UNITED STATES PATENT AND TRADEMARK OFFICE

Office Action Summary

10/805,824

DETAILED ACTION

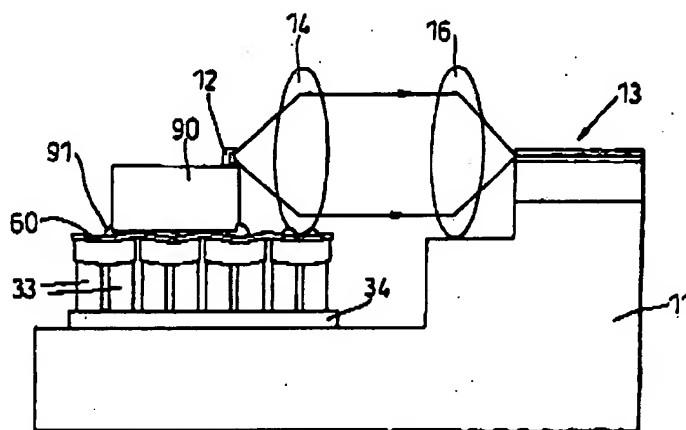
Regarding **claim 1**, Fig 9 of '143 discloses "an optoelectronic apparatus comprising:

a substrate [11] having a stepped surface having a lower and an upper portion;
a thermal electric cooler (TEC) disposed on the lower portion of the stepped surface of the substrate, the TEC having a plurality of elongated TEC elements [33] disposed substantially in parallel between a top [32] and a bottom [34] portion of the TEC, the top portion [32] of the TEC having a top planar surface that is substantially orthogonal to the TEC elements [33];

and a laser light source [12] disposed on the top planar surface [32] of the TEC."

Regarding **claims 6, 8, 23, 24**, Fig 9 of '143 discloses an optoelectronic apparatus as described above:

6. "wherein the apparatus further comprises a selected one of a driver and an

amplifier [13, 15] disposed on an upper portion of the stepped surface of the substrate [11], and coupled to the laser light source [12]";

8. "wherein the laser light source [12] comprises a laser diode device";

23. "wherein said laser light source [12] is disposed on the top planar surface of the top portion [32] of the TEC to emit light bundles in a direction parallel to the top planar surface";

24. "wherein said laser light source [12] is disposed directly on the top planar surface of the top portion [32] of the TEC" (Fig 8)
